# SKYLINE AT LORSON RANCH

EL PASO COUNTY, CO  
**PLANNED UNIT DEVELOPMENT AND  
 PRELIMINARY PLAN**

# PUDSP V\_1 Planning Redlines Only.pdf Markup Summary 3-10-2021

**LS01**  
**SHEET 05 OF 07**

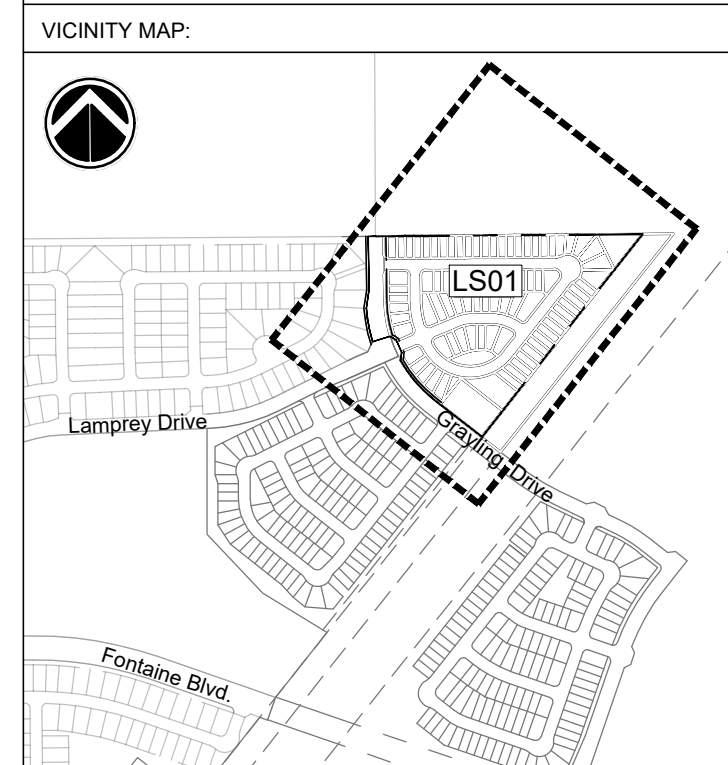
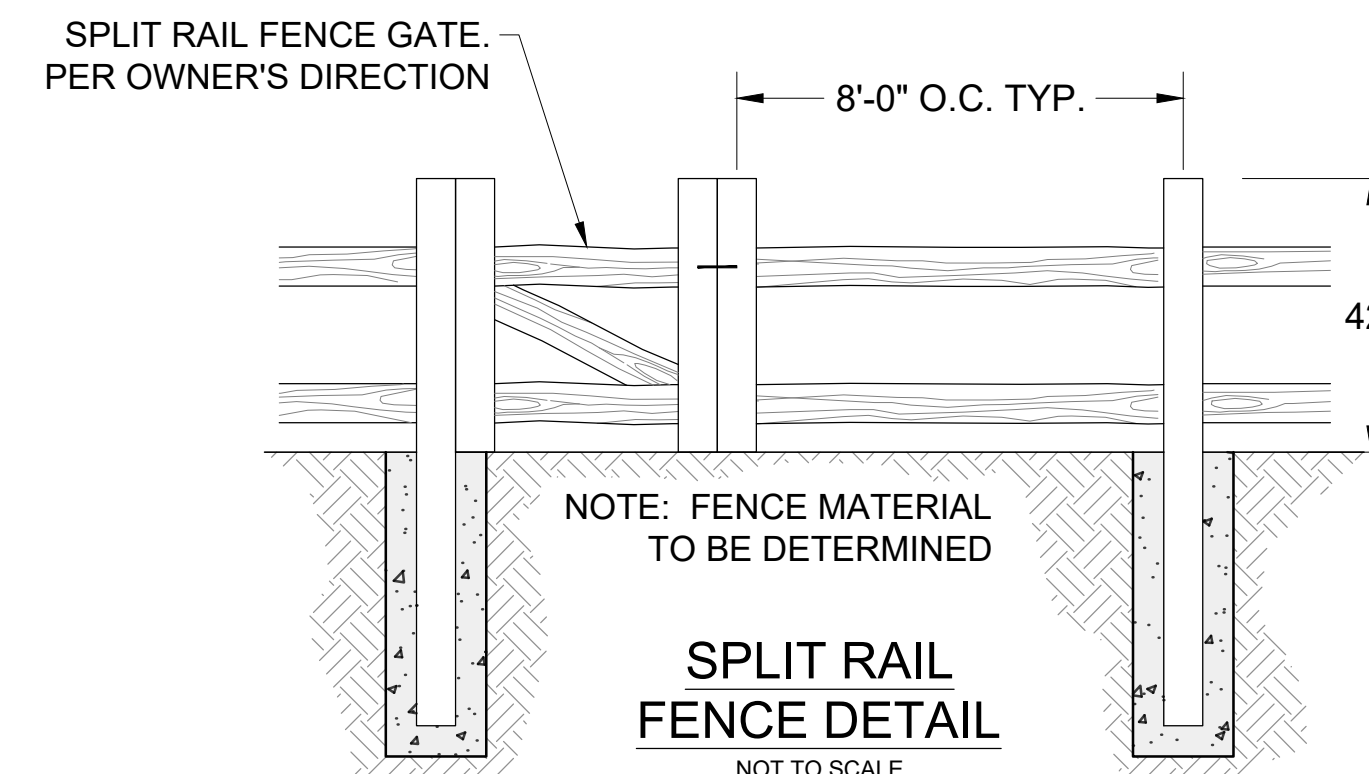
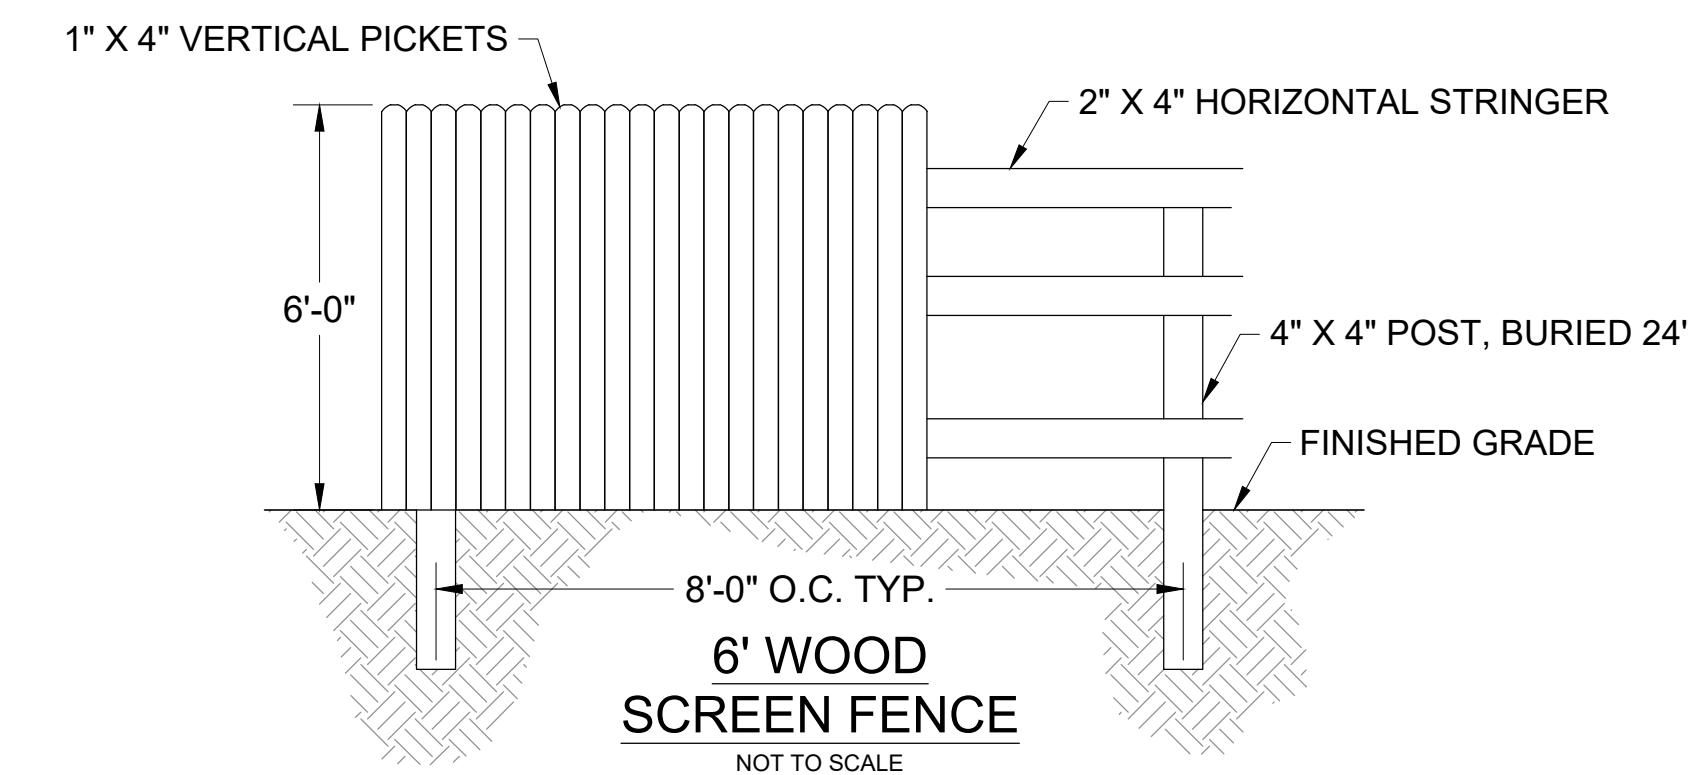
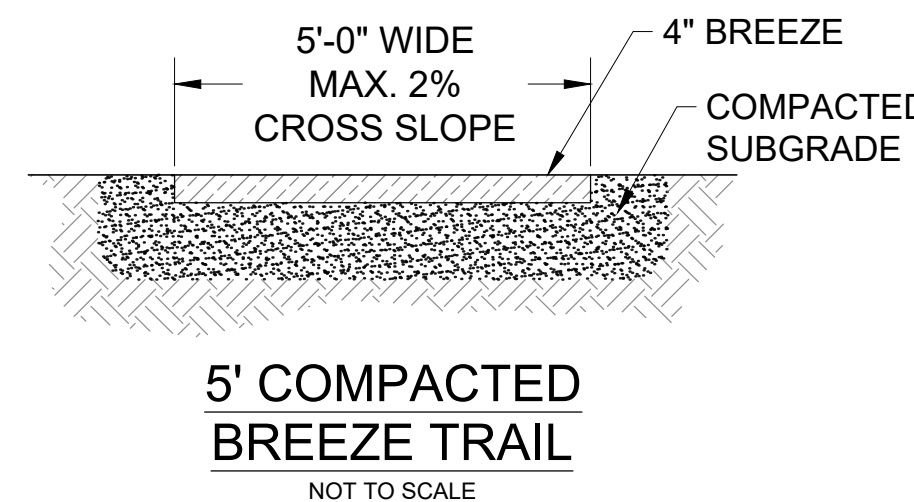
Add the Pump Station landscape and detail

what is this graphic depicting?

SP01

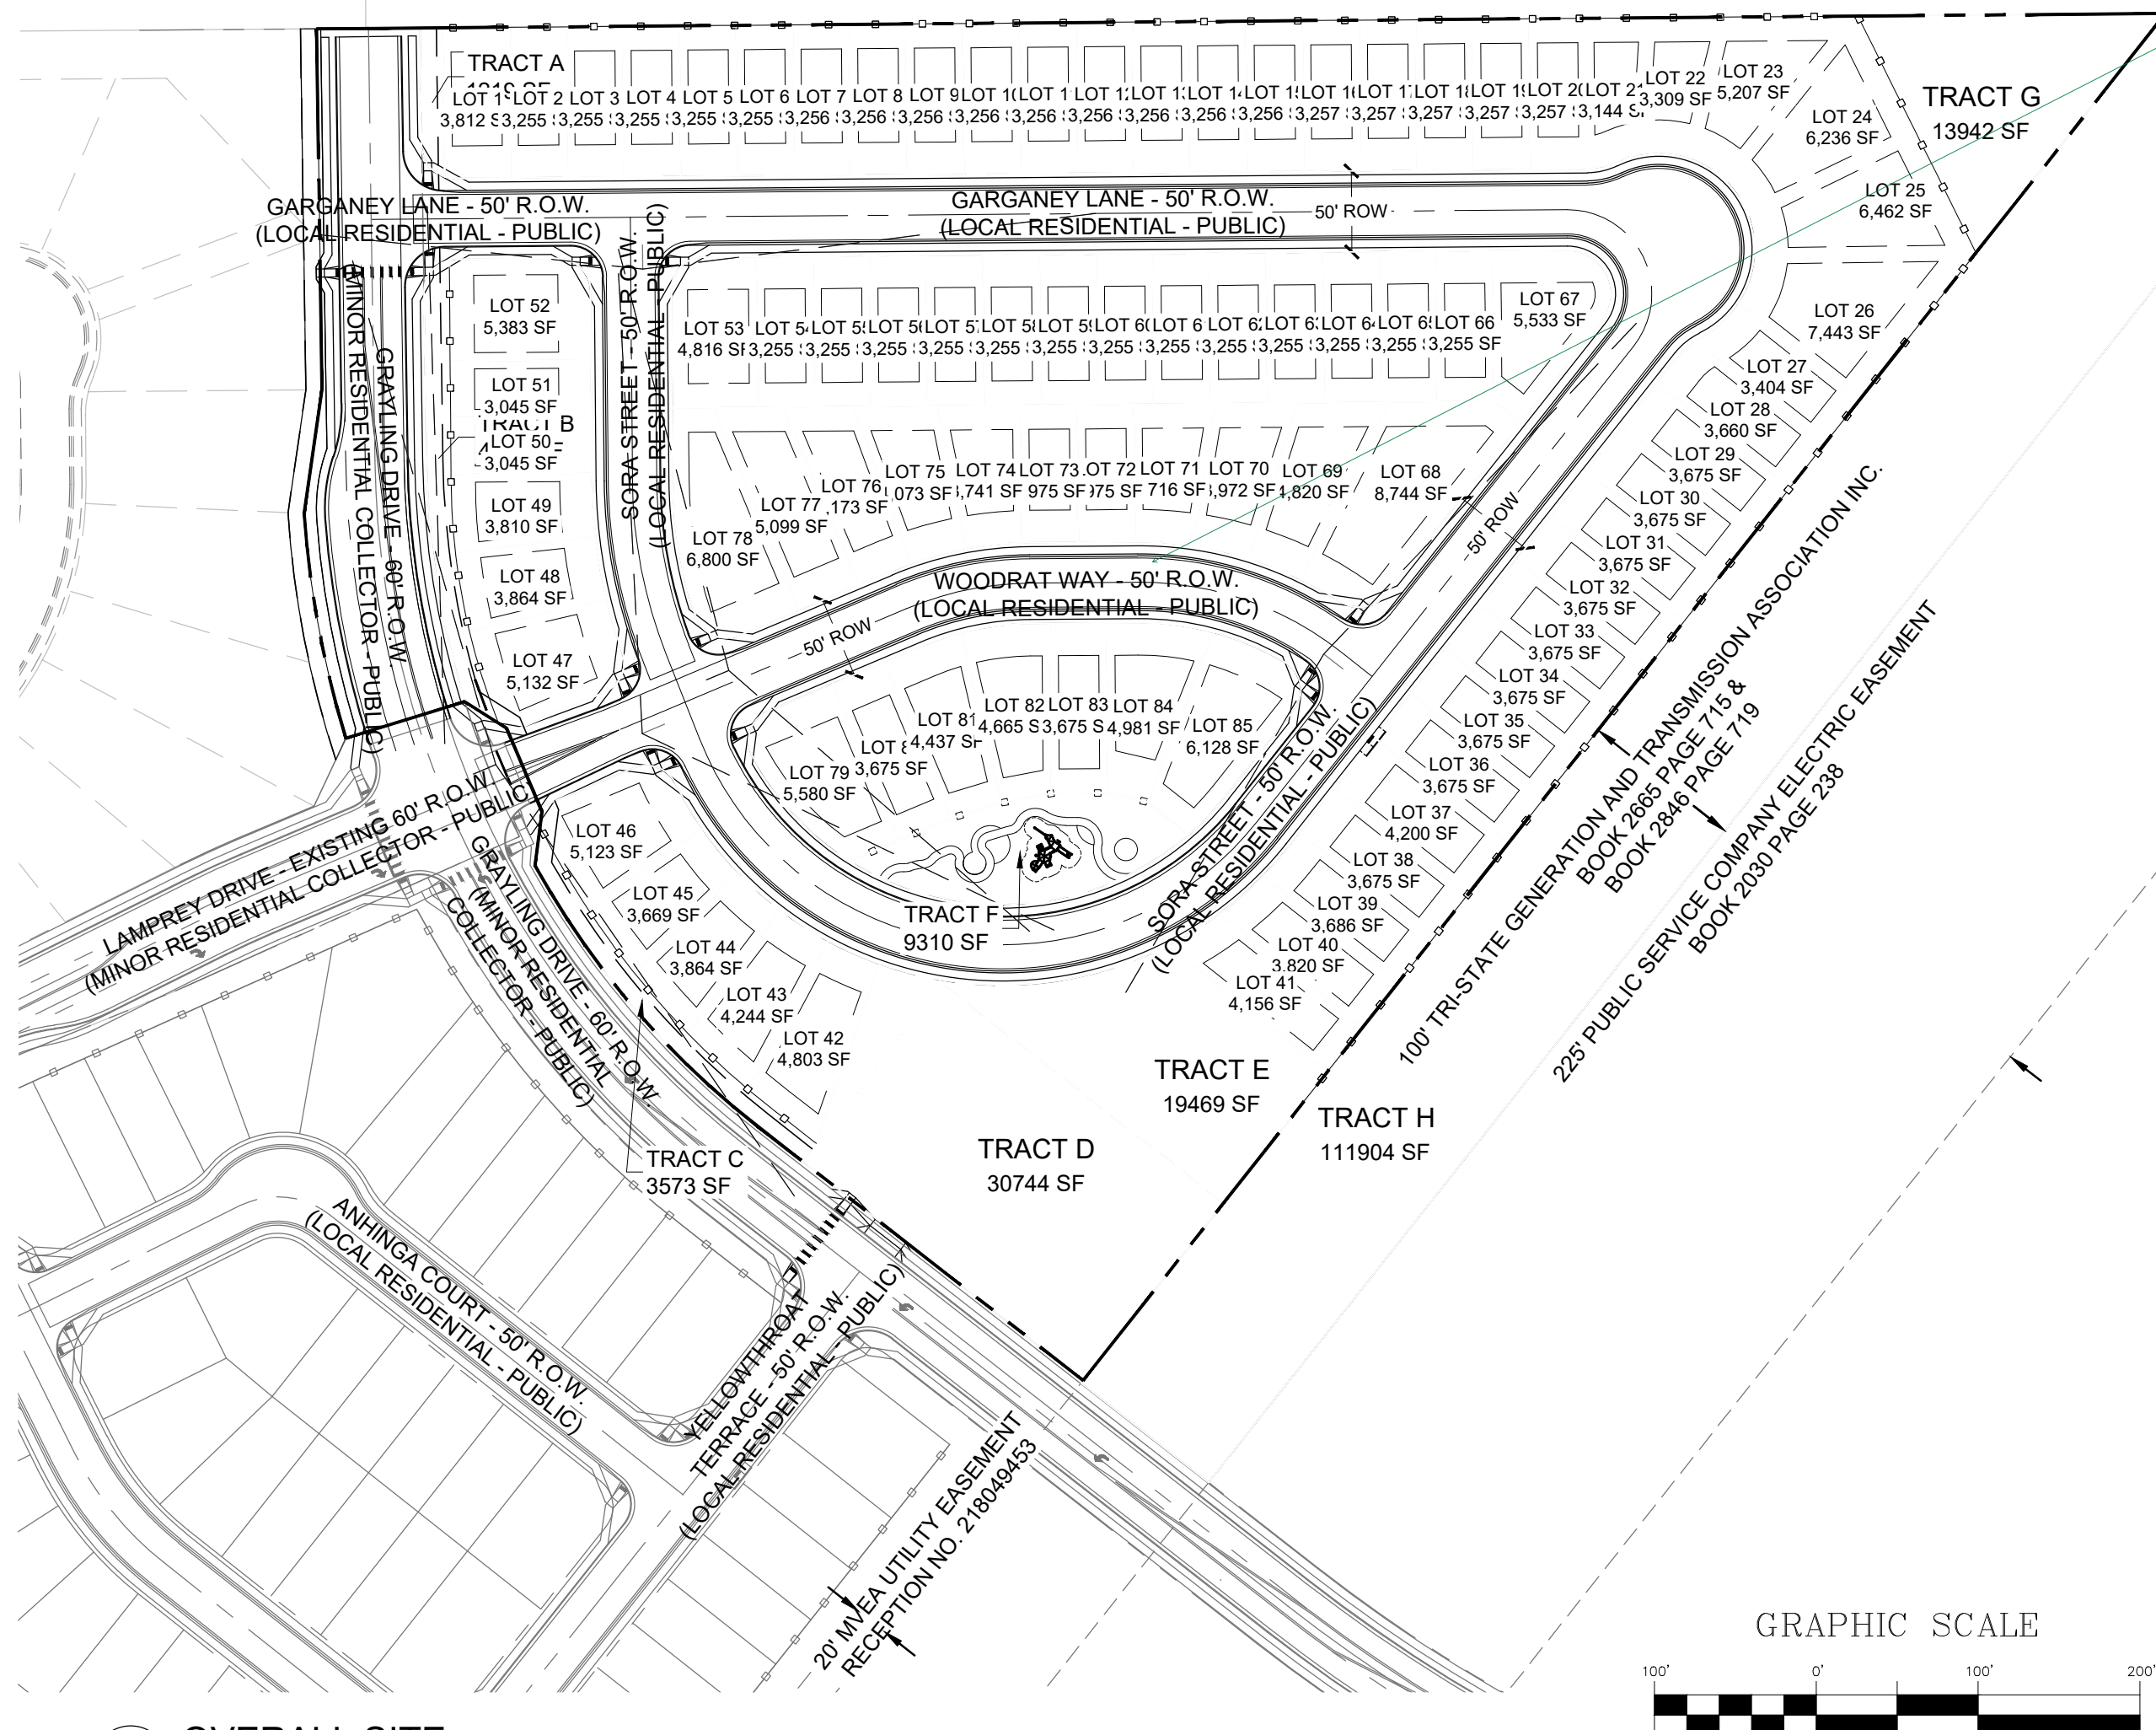
are the proposed  
 contours correct  
 here?

Any trail connectivity  
 provided?

is this a fence so the  
 open space is not  
 accessible (useable)?  
 Add a path tract  
 between lots?

is this a separate  
 tract?

depict all SF,  
 distances, bearings  
 for all tracts. The  
 tracts should close.

landscape should be provided for these tracts and any other tracts that will be  
 built on...as well as dimensional standards
